January 10, 2020

**FROM:** Christopher Leswing, Director, Building & Planning Department

**SUBJECT: TENTATIVE SKETCH PLAN – 38 W. Lancaster Avenue, Ardmore Theatre, Ardmore, LD# 3838, Ward 4.**

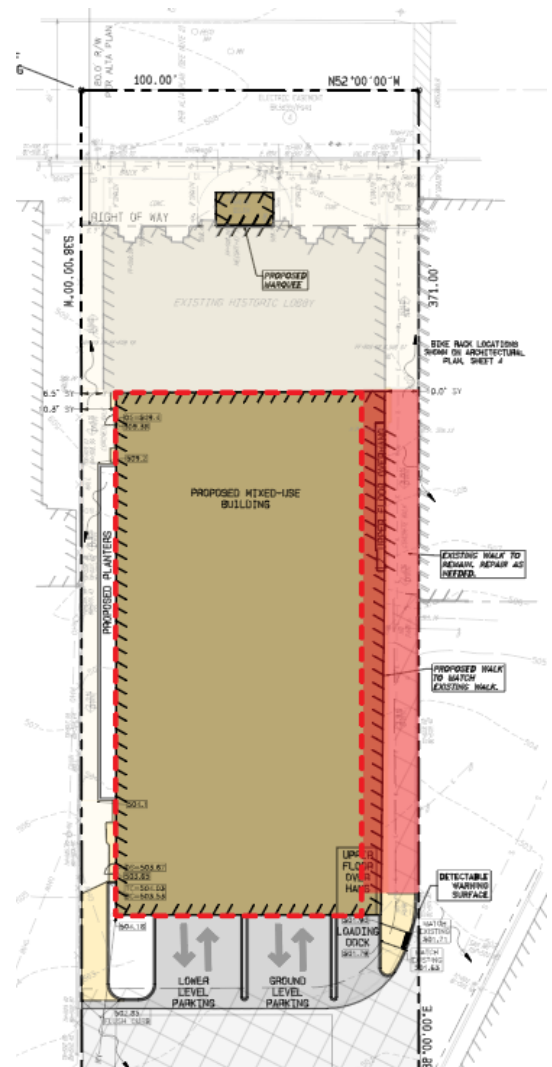
This site is in the middle of downtown Ardmore, one of the Township's most walkable communities. Staff recommends the applicant work with the Township to maximize safe pedestrian access to and through the site resulting in less traffic in the nearby neighborhoods. Currently, members of the public are able to traverse the site from areas south of Lancaster Avenue to reach destinations on the north side of Ardmore. The applicant should identify if this public access will remain once the project is complete.

Staff has included a condition requiring a pedestrian circulation plan, which includes crosswalks, preferably raised, to connect the sidewalk that surrounds the proposed structure along the southeastern and southwestern elevation to the existing pedestrian pathways adjacent to the property. Staff has also included a condition requiring the applicant to work with Township staff to provide lighting, signage and other safety measures along the two alleyways on either side of the building.

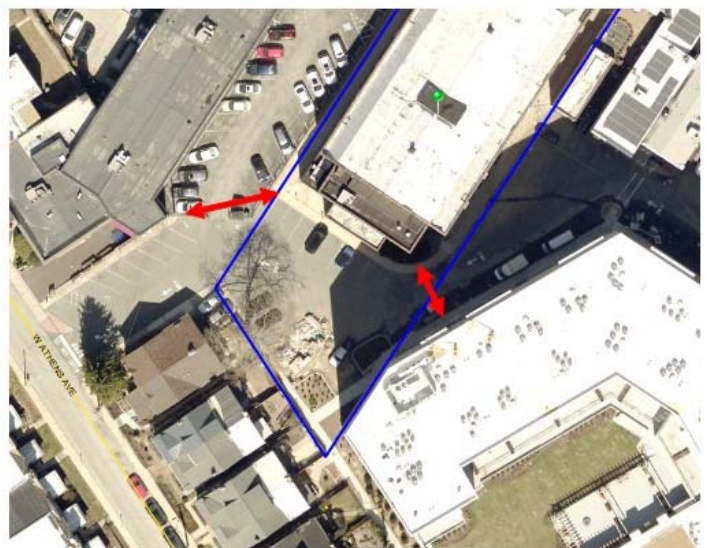
The applicant has indicated that the agreement will be terminated as part of this project and that of the 16 existing parking spaces in the leased area, eight of them will be removed and the remaining eight spaces will be used to satisfy the parking requirement of the project. The pedestrian use of the ten foot wide alley appears to remain, but staff requests that the applicant provide clarification on this to the Planning Commission. Staff also requests that the applicant consider granting easements to the Township to access/traverse the site with vehicles and grant pedestrian access to the alleys on both sides of the building.
